Addendum No. 4

Reference: Unified State Laboratory – Module 2
Department of Public Safety
Department of Health
Department of Agriculture and Food
DFCM Project No. 13020300

Addendum #2

PROJECT NAME: Unified State Laboratory Module 2

LEVEL 1 WASTE AND VENT PLAN AREA C
 1/8" = 1'-0" PW101C

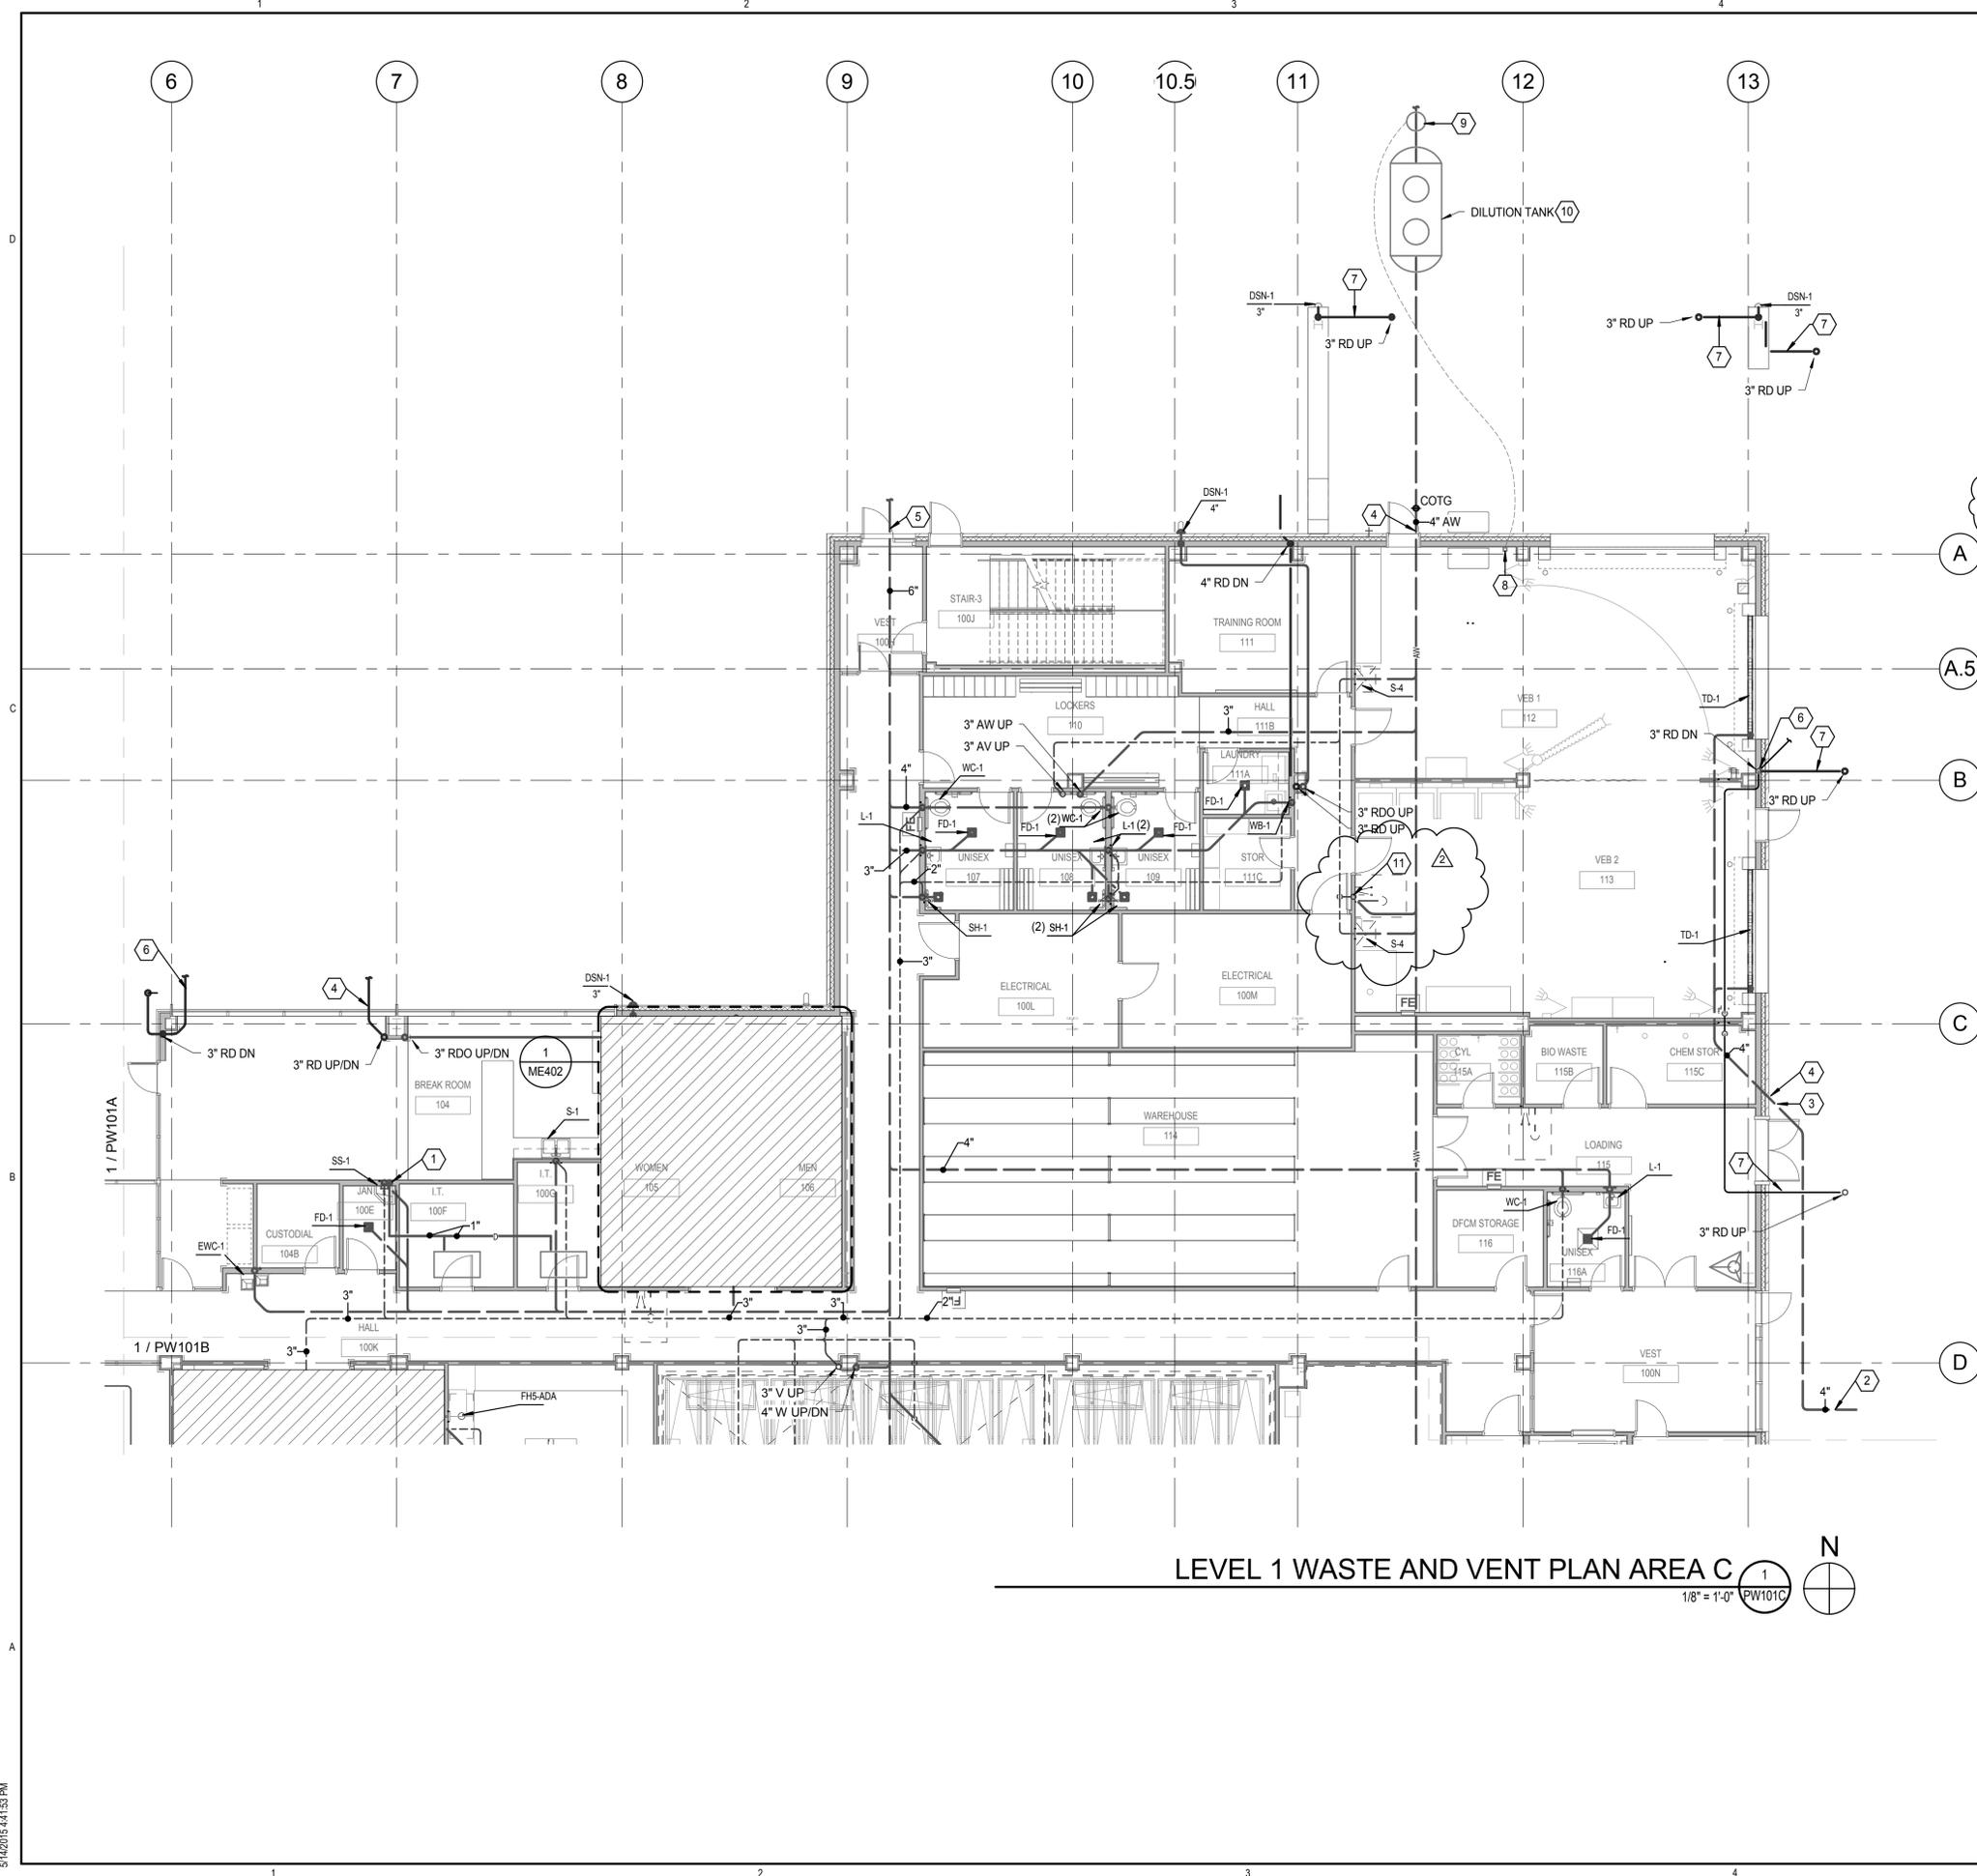
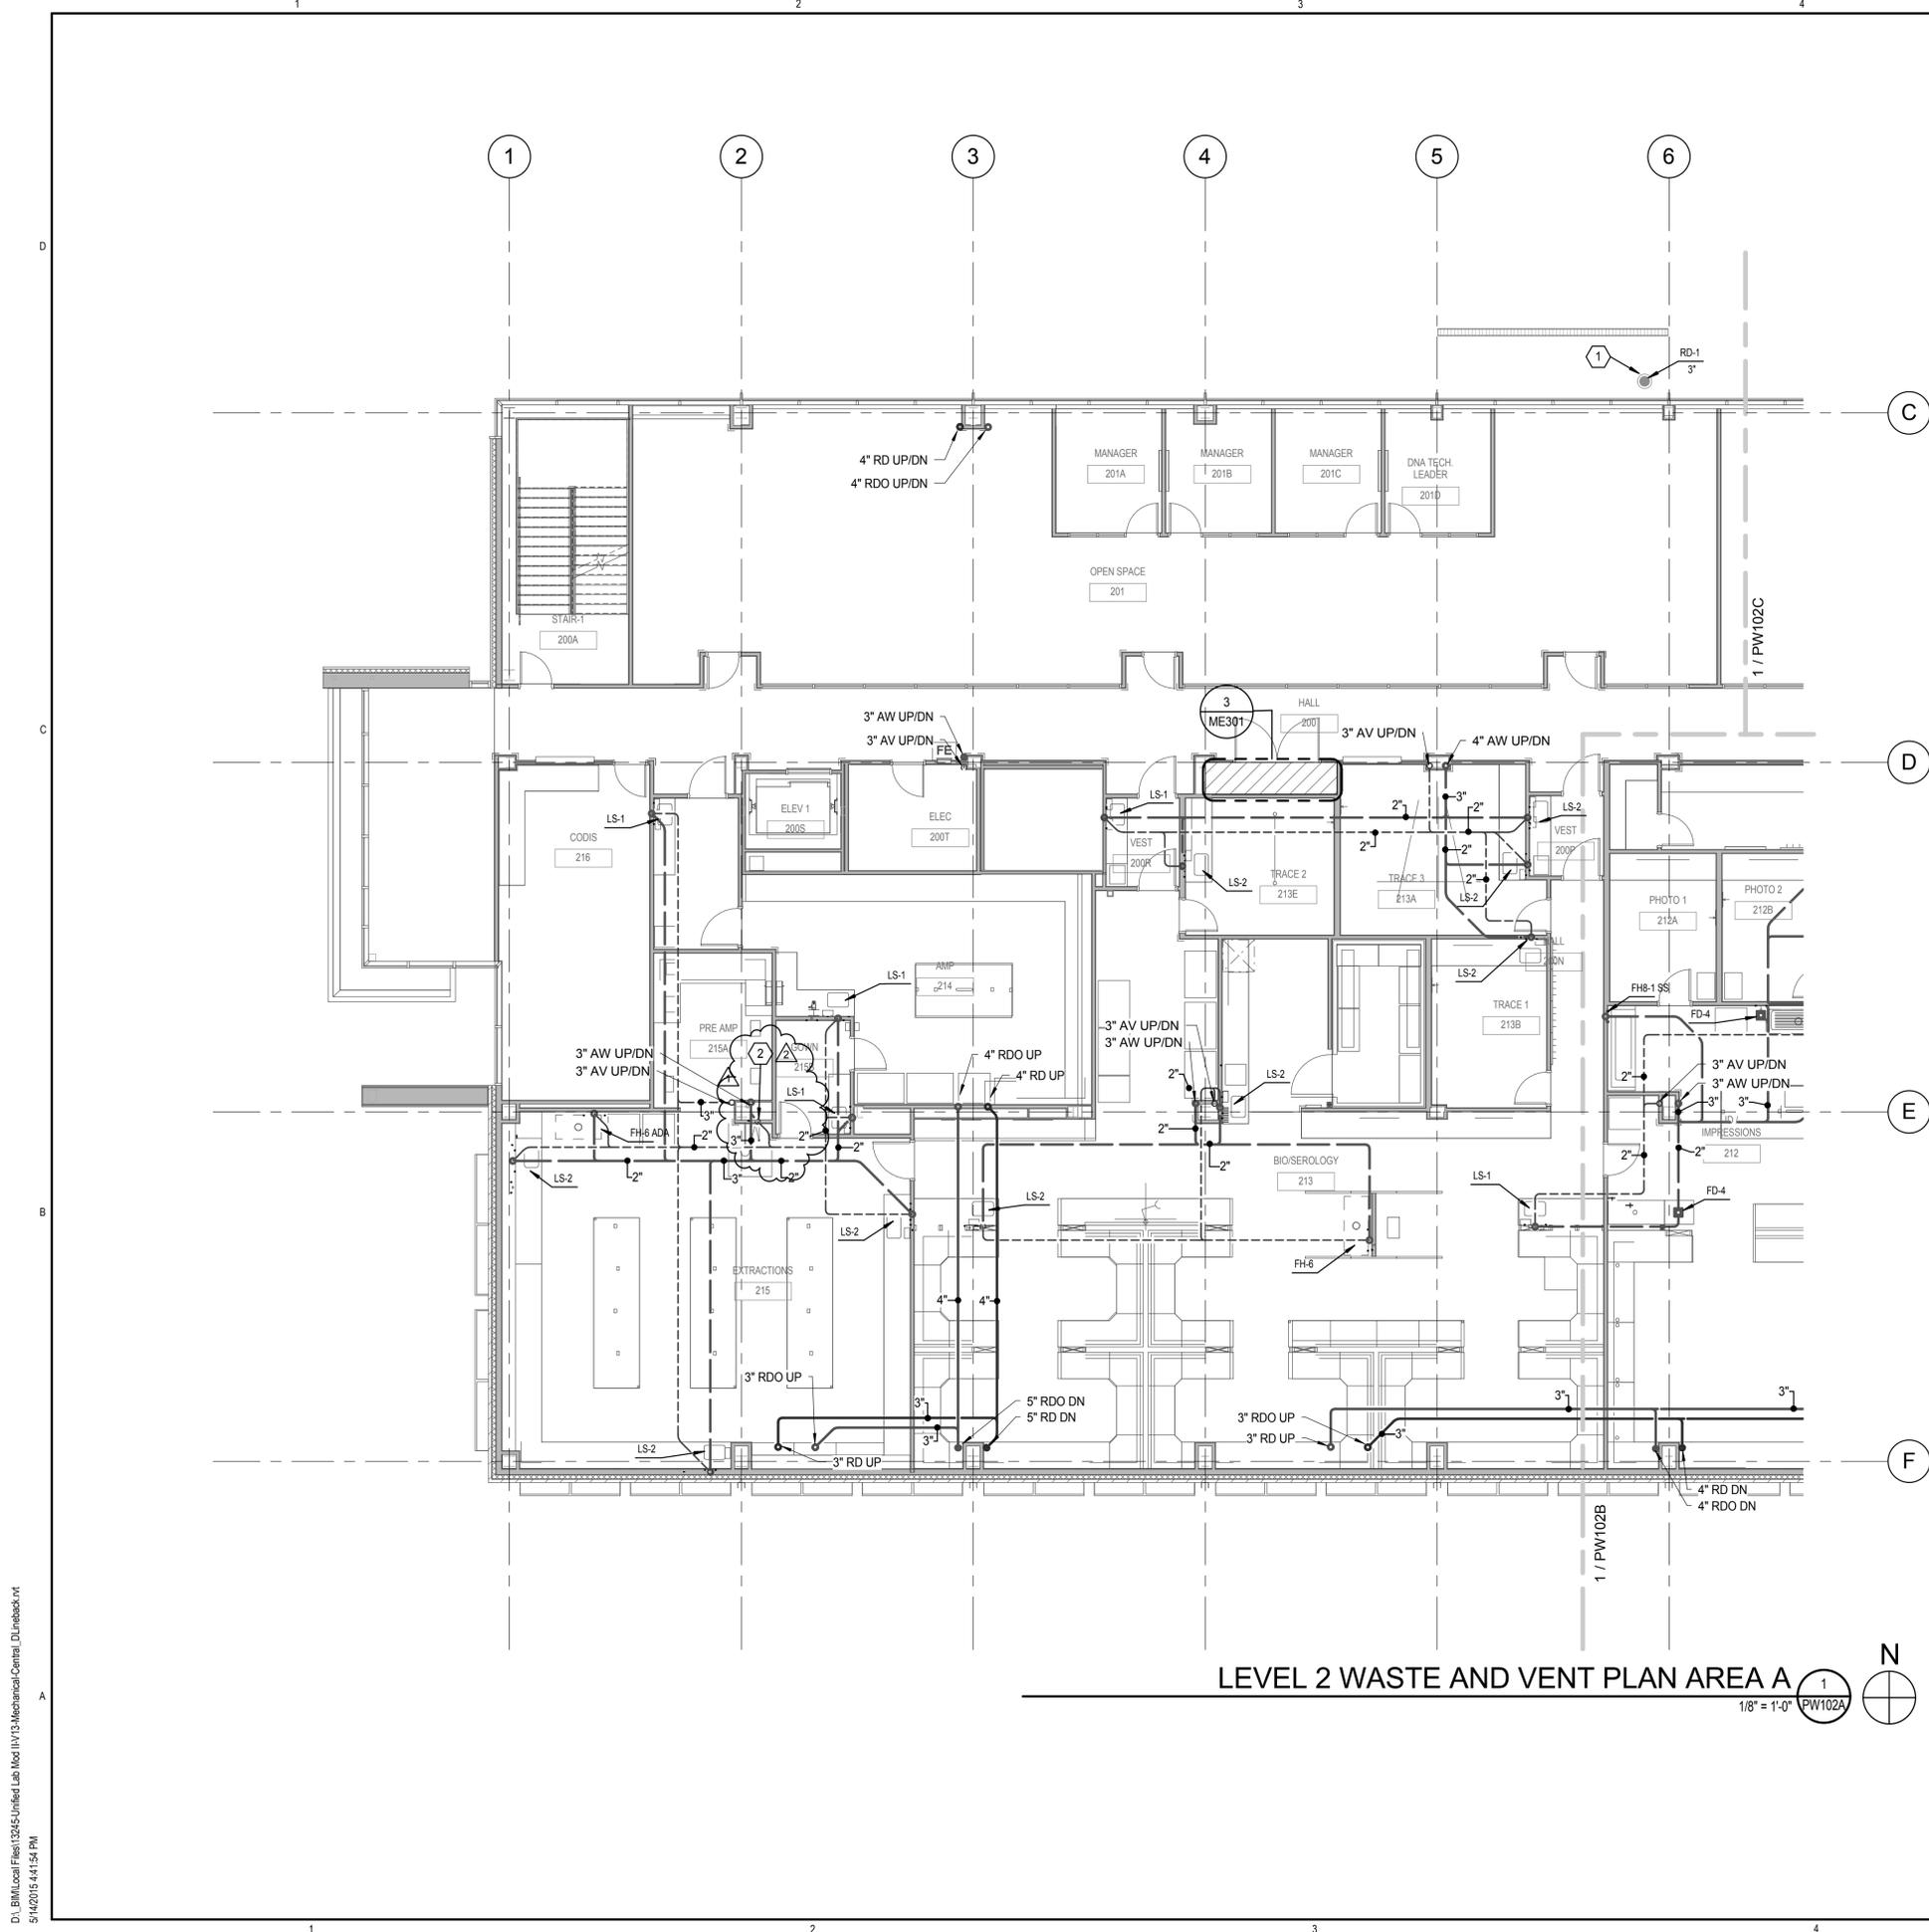
1. Add waste and vent connection and keyed note to eyewash portion of emergency wash station in VEB 2-113.
